Clonburris SDZ, Reg ref: SDZ22A0010  
Dublin 22

Ronan Mac Diarmada & Associates

## COMPLIANCE RESPONSE

## Condition Request 26 (i - xv )

### Western Open Space

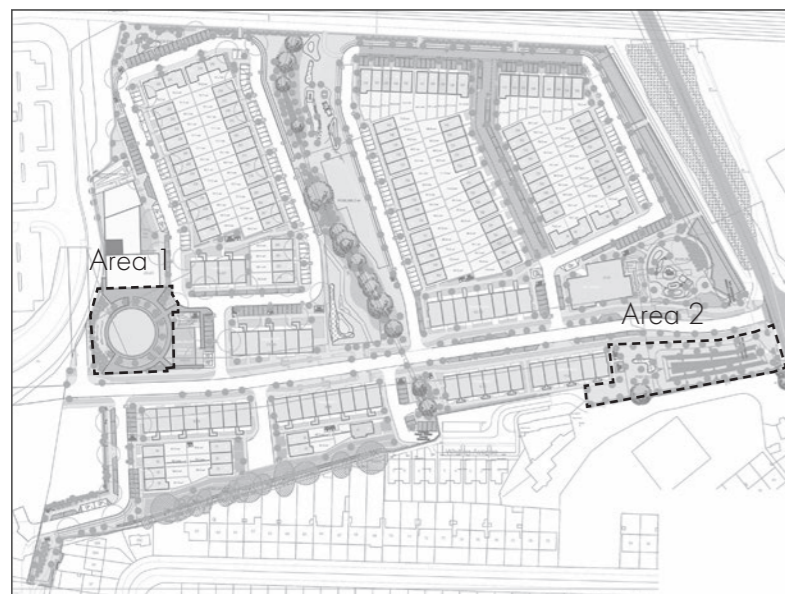
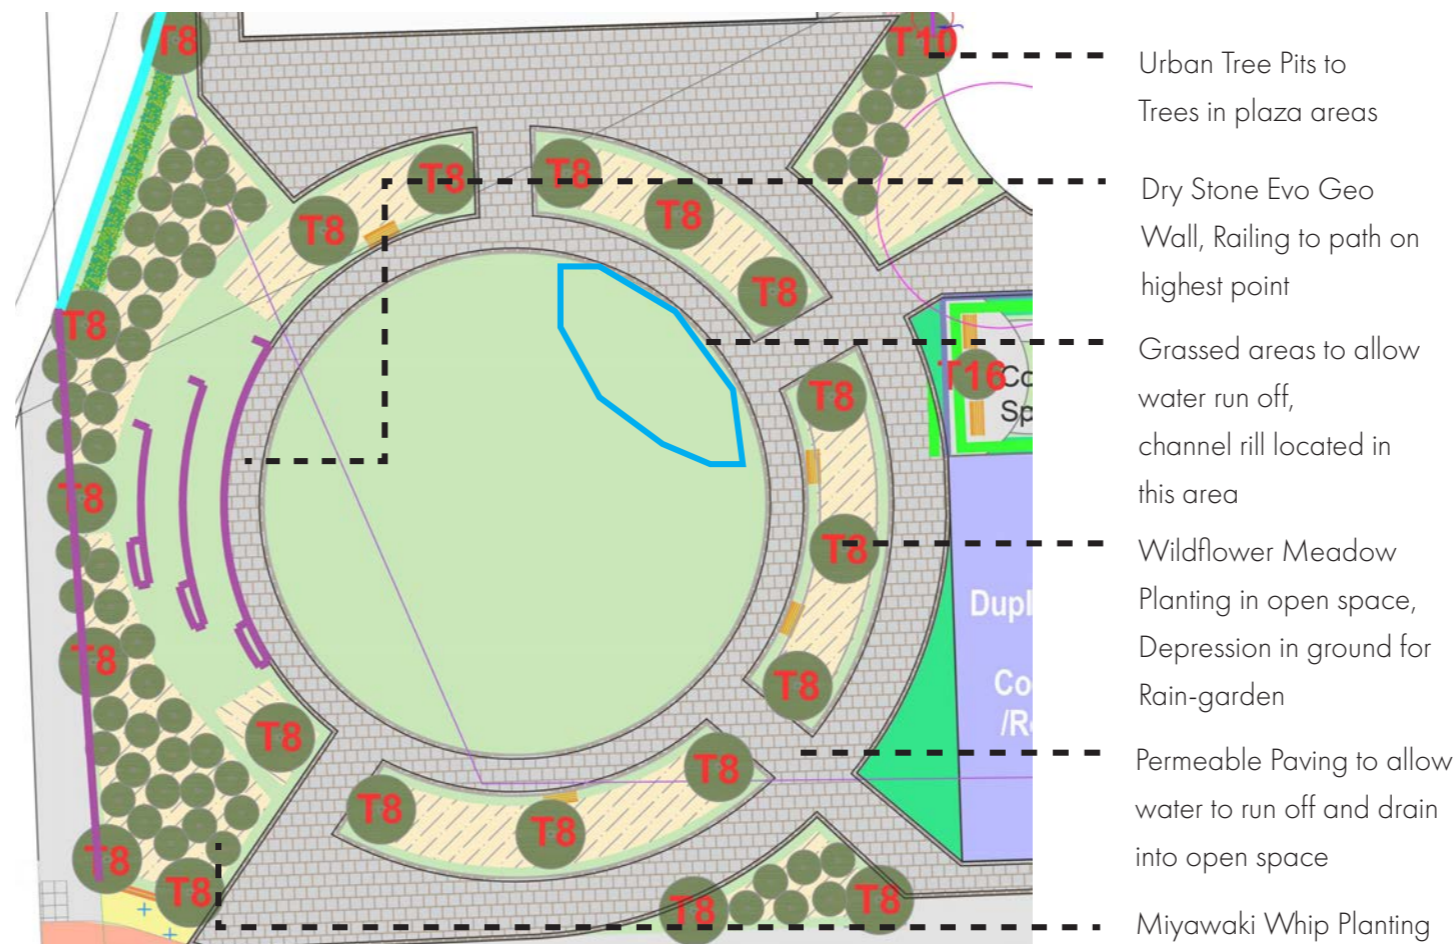
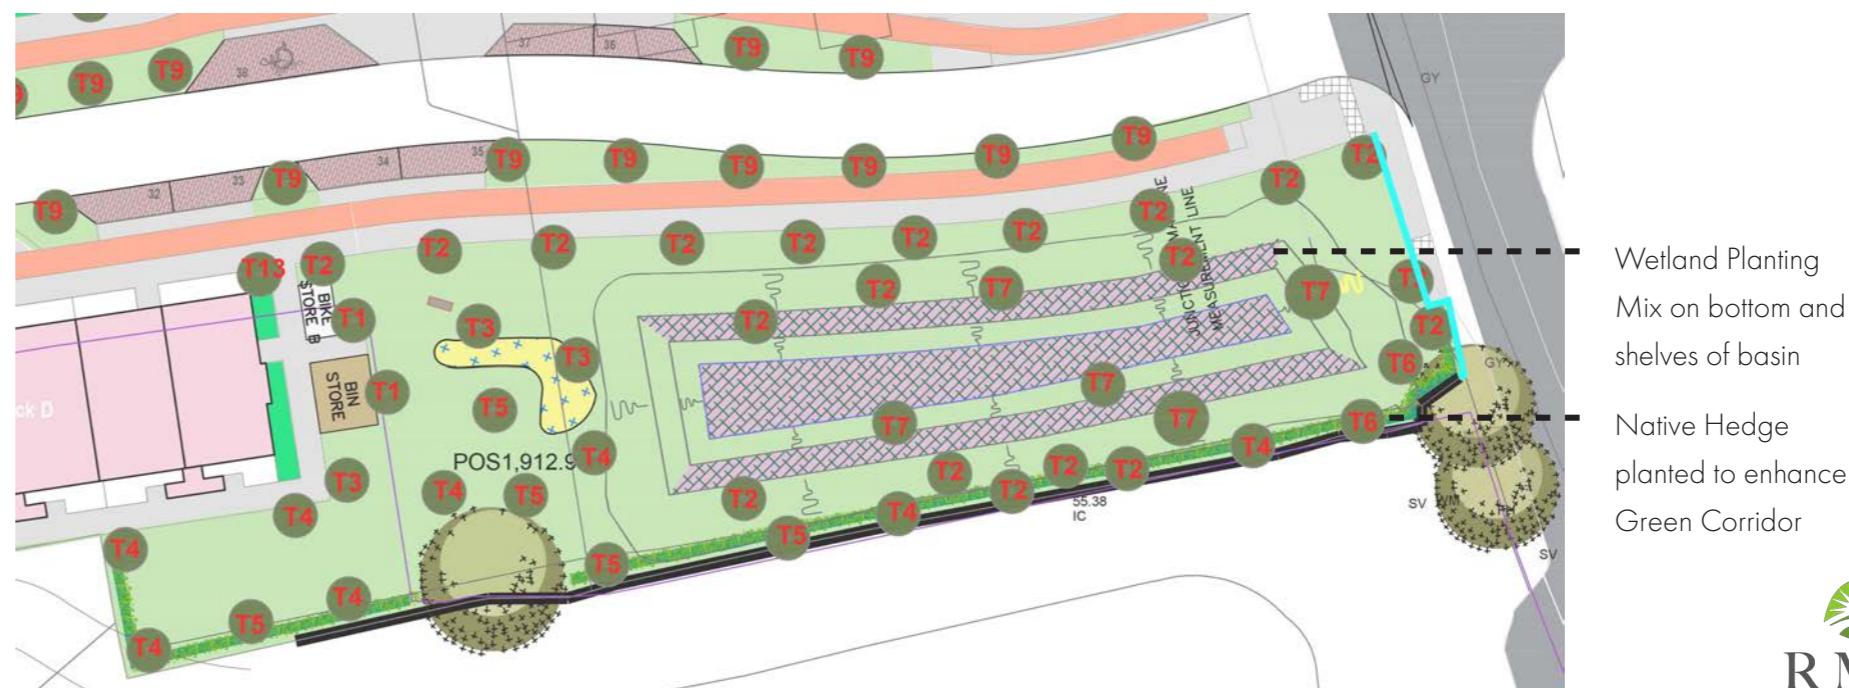
(i) Revised design for plaza incorporating Green Infrastructure and natural SUDS

(ii) Revised design of Public Open Space with detention ponds to incorporate shelves and planting.

(i) The design for the plaza has been revised to incorporate natural SuDS and green infrastructure. We have included raingardens within the open space and also tree pits will be used where applicable.

(ii) The Public Open Space incorporates shelving and planting within the detention pond. The detention pond is a part of infrastructure works done on SDZ20A/0021 and has been built and completed in accordance to the granted permission plans.

As per coordination with Pinnacle Engineers, the Public Open Space to the South-East of the site will incorporate shelves and wetland planting.

### Western Open Space

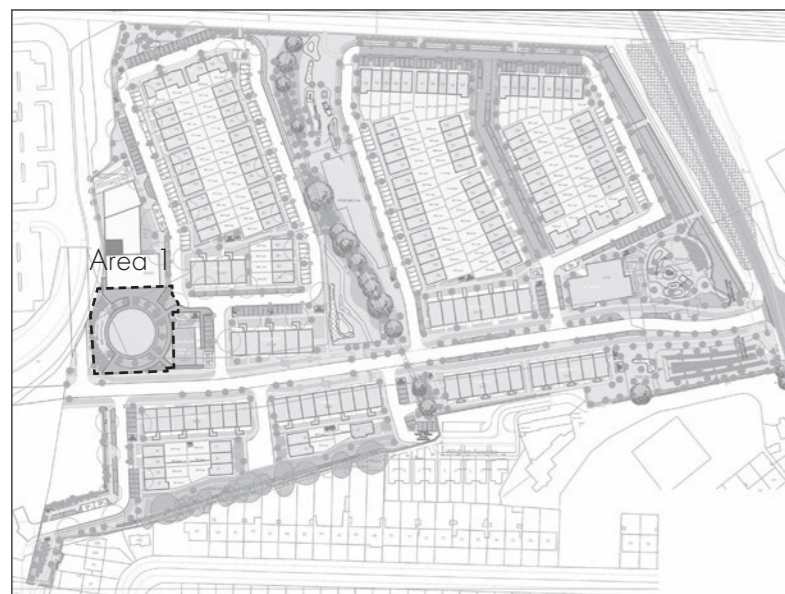
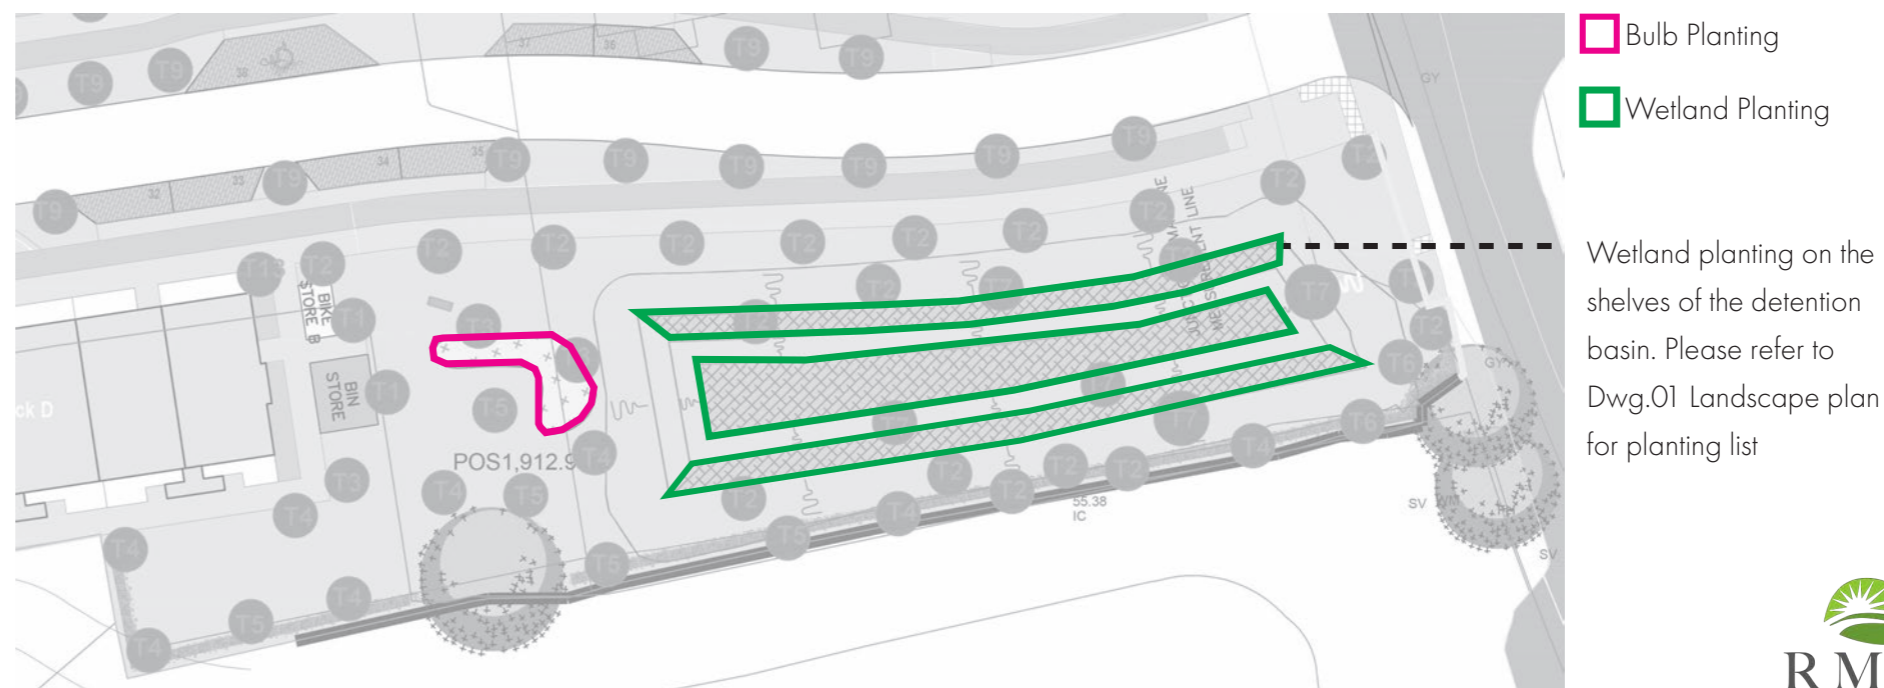
(i) Revised design for plaza incorporating Green Infrastructure and natural SuDS

(ii) Revised design of Public Open Space with detention ponds to incorporate shelves and planting.

(i) The design for the plaza has been revised to incorporate natural SuDS and green infrastructure. We have included raingardens within the open space and also tree pits will be used where applicable.

(ii) The Public Open Space incorporates shelving and planting within the detention pond. The detention pond is a part of infrastructure works done on SDZ20A/0021 and has been built and completed in accordance to the granted permission plans.

As per coordination with Pinnacle Engineers, the Public Open Space to the South-East of the site will incorporate shelves and wetland planting.

### Eastern Open Space

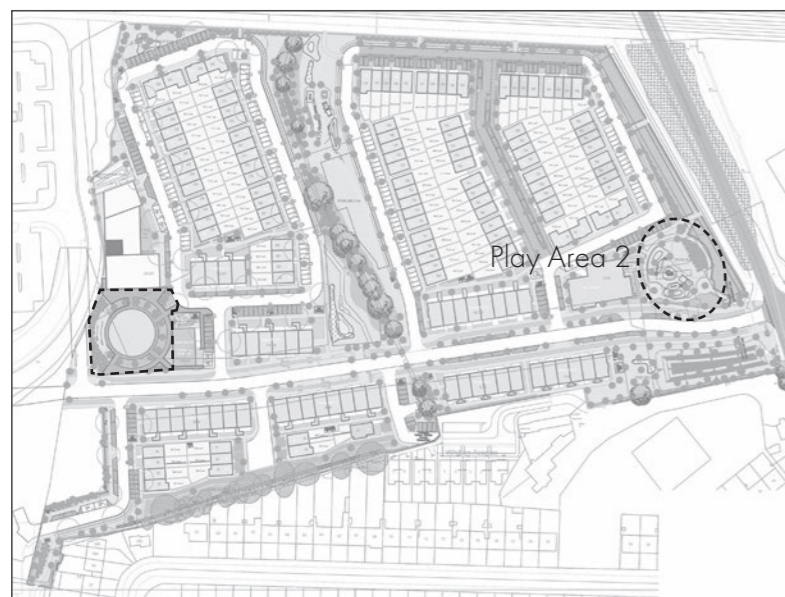
(iii) Revised open space and play design on open space in east of site, north of link road.

(v) Open space areas along all roads to incorporate natural Suds for attenuation, water treatment, amenity and biodiversity purposes as outlined in SDZ. Details of all natural SuDS features including swales, rain gardens, bioretention tree pits, channel rills, filter strips, ponds, detention basins with lower areas allowed to fill first (low flow channels), wetlands etc. to be agreed with Public Realm

(iii) The open space to the east has been revised. The play equipment and design has been revised to reflect the change in layout. SuDS elements have also been included in the form of swales to the perimeter of the space.

(v) Open space areas along all roads incorporate natural Suds for attenuation, water treatment, amenity and biodiversity purposes as outlined in SDZ. Please refer to details shown for treatment of swales and detention basin in SUDS Strategy document.

### Eastern Open Space- SUDs Features

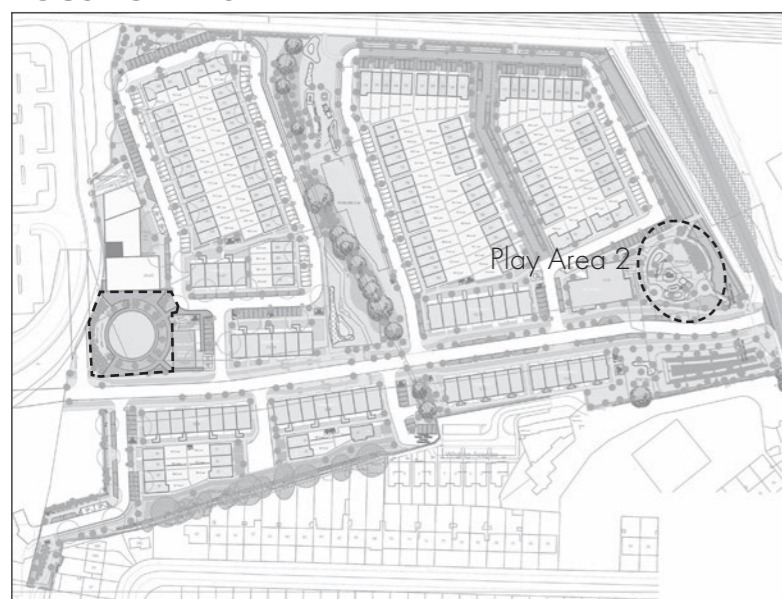
(iii) Revised open space and play design on open space in east of site, north of link road.

(v) Open space areas along all roads to incorporate natural Suds for attenuation, water treatment, amenity and biodiversity purposes as outlined in SDZ. Details of all natural SuDS features including swales, rain gardens, bioretention tree pits, channel rills, filter strips, ponds, detention basins with lower areas allowed to fill first (low flow channels), wetlands etc. to be agreed with Public Realm

(iii) The open space to the east has been revised. The play equipment and design has been revised to reflect the change in layout. SuDS elements have also been included in the form of swales to the perimeter of the space.

(v) Open space areas along all roads incorporate natural Suds for attenuation, water treatment, amenity and biodiversity purposes as outlined in SDZ. Please refer to details shown for treatment of swales and detention basin in SUDS Strategy document.

### Swale Detail

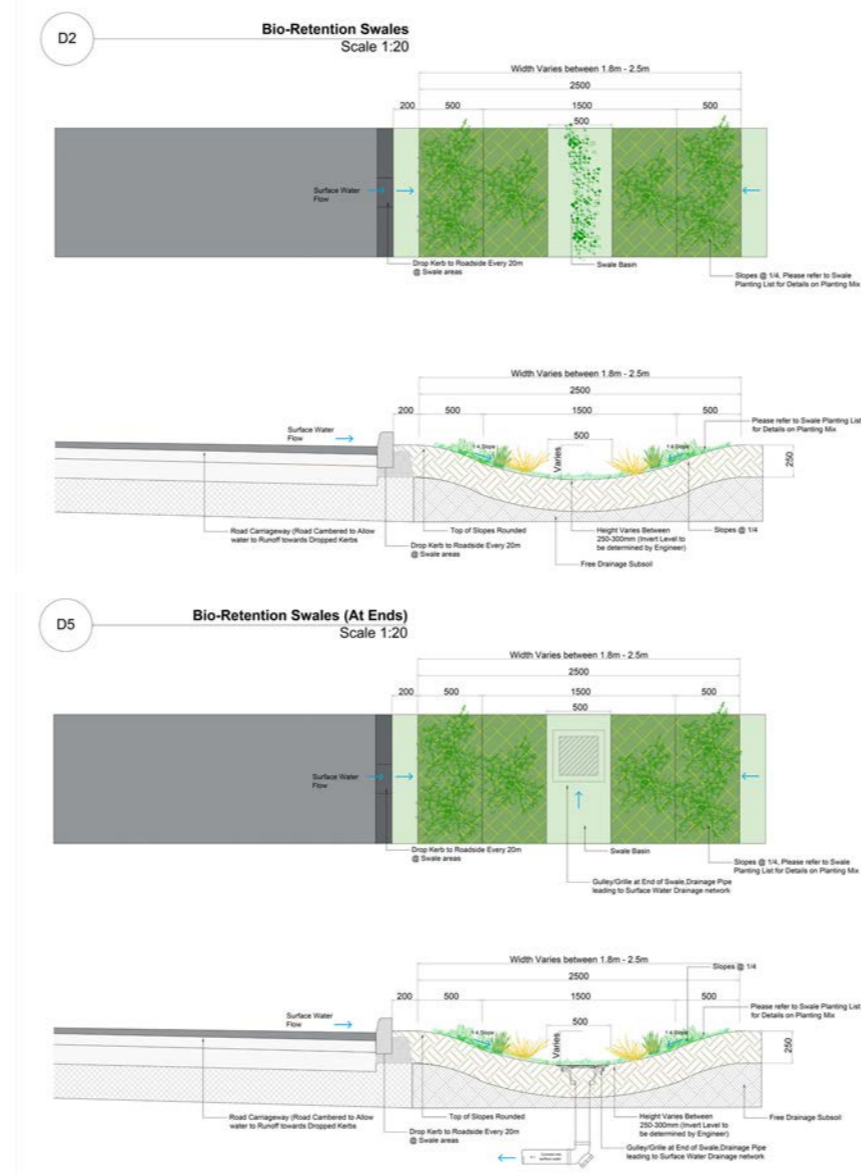
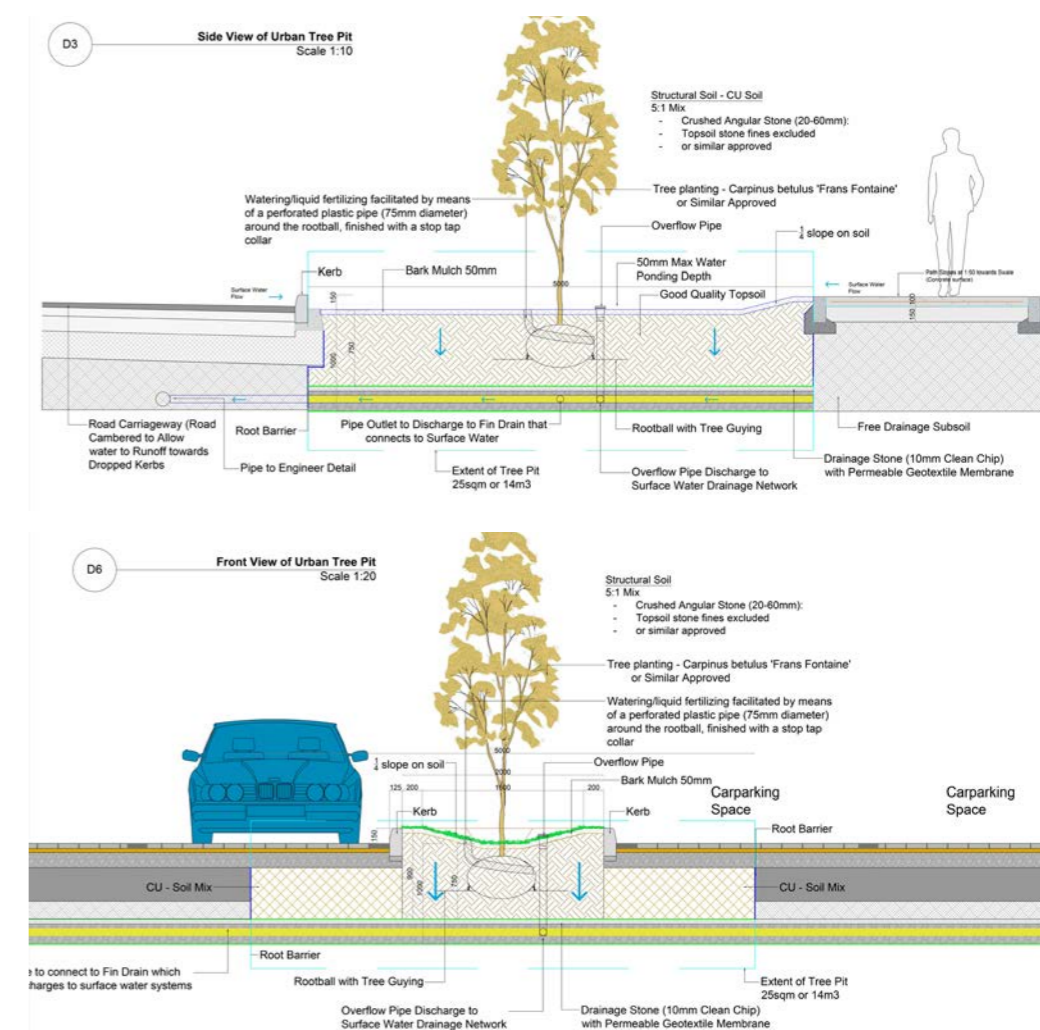
(iii) Revised open space and play design on open space in east of site, north of link road.

(v) Open space areas along all roads to incorporate natural Suds for attenuation, water treatment, amenity and biodiversity purposes as outlined in SDZ. Details of all natural SuDS features including swales, rain gardens, bioretention tree pits, channel rills, filter strips, ponds, detention basins with lower areas allowed to fill first (low flow channels), wetlands etc. to be agreed with Public Realm

(iii) The open space to the east has been revised. The play equipment and design has been revised to reflect the change in layout. SuDS elements have also been included in the form of swales to the perimeter of the space.

(v) Open space areas along all roads incorporate natural Suds for attenuation, water treatment, amenity and biodiversity purposes as outlined in SDZ. Please refer to details shown for treatment of swales and detention basin in SUDS Strategy document.

Also, please refer to SUDS Strategy Document included for details on Tree Pits, Swales and Raingardens.

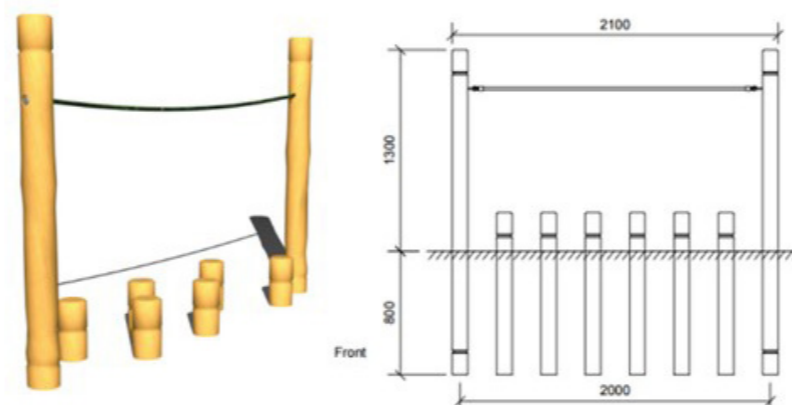
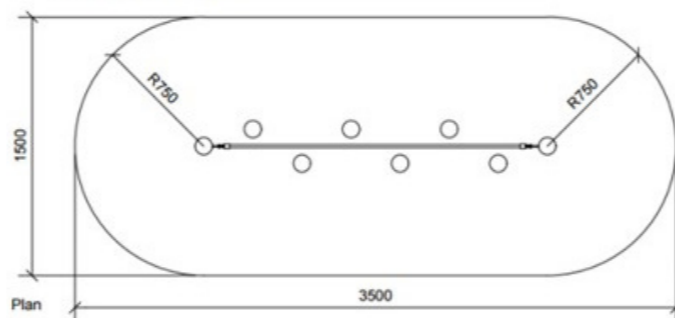
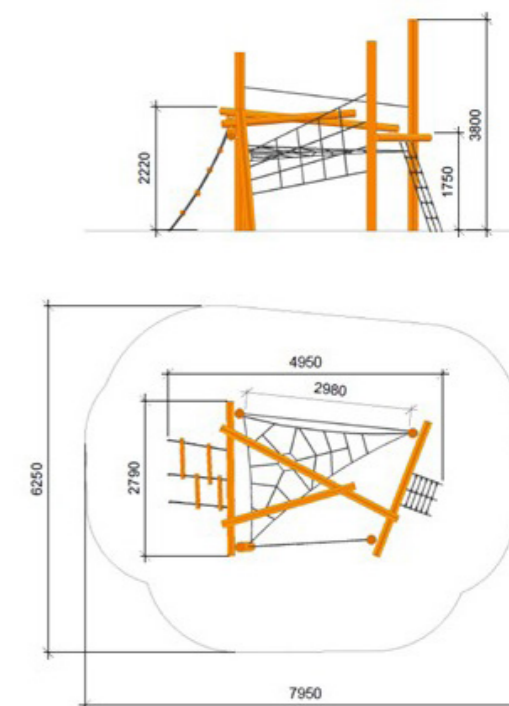
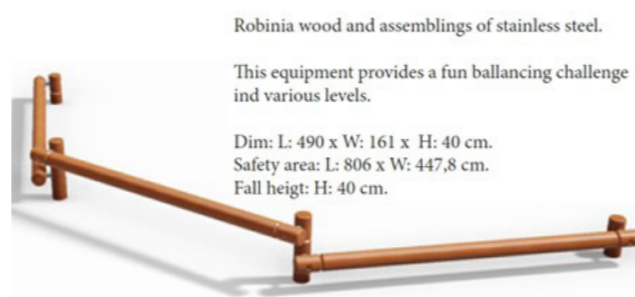
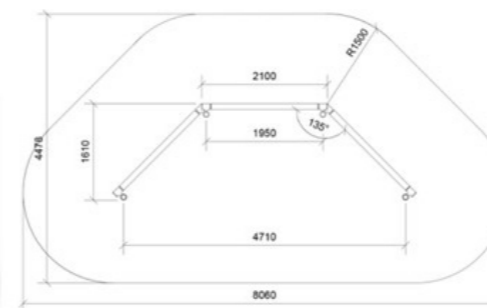
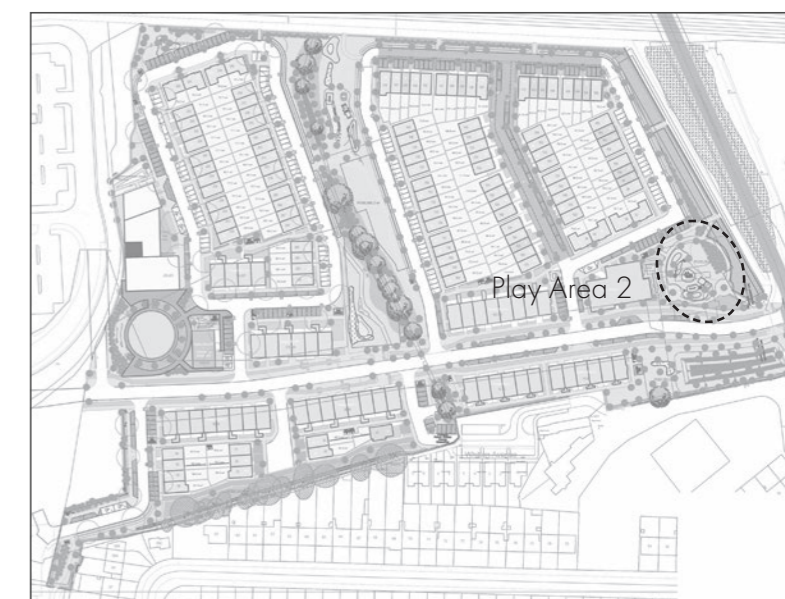
(iii) Revised open space and play design on open space in east of site, north of link road.

(iv) Revised play design at central open space

(v) Open space areas along all roads to incorporate natural SuDS for attenuation, water treatment, amenity and biodiversity purposes as outlined in SDZ. Details of all natural SuDS features including swales, rain gardens, bioretention tree pits, channel rills, filter strips, ponds, detention basins with lower areas allowed to fill first (low flow channels), wetlands etc. to be agreed with Public Realm.

(xv) Details of all play items and natural play features to be provided and agreed with SDCC Public Realm Section. All play areas must be universally accessible.

(iii) The open space to the east has been revised. The play equipment and design has been revised to reflect the change in layout. SuDS elements have also been included in the form of swales to the perimeter of the space.

(iv) The central open space has been revised to incorporate SuDS elements as well as revised play items.

(v) Open space areas along all roads incorporate natural SuDS for attenuation, water treatment, amenity and biodiversity purposes as outlined in SDZ. Please refer to details shown for treatment of swales and detention basin in SUDS Strategy document.

(xv) Details of play items and natural play features are provided in response and will be agreed with SDCC Public Realm Section prior to works. All play areas will be universally accessible.
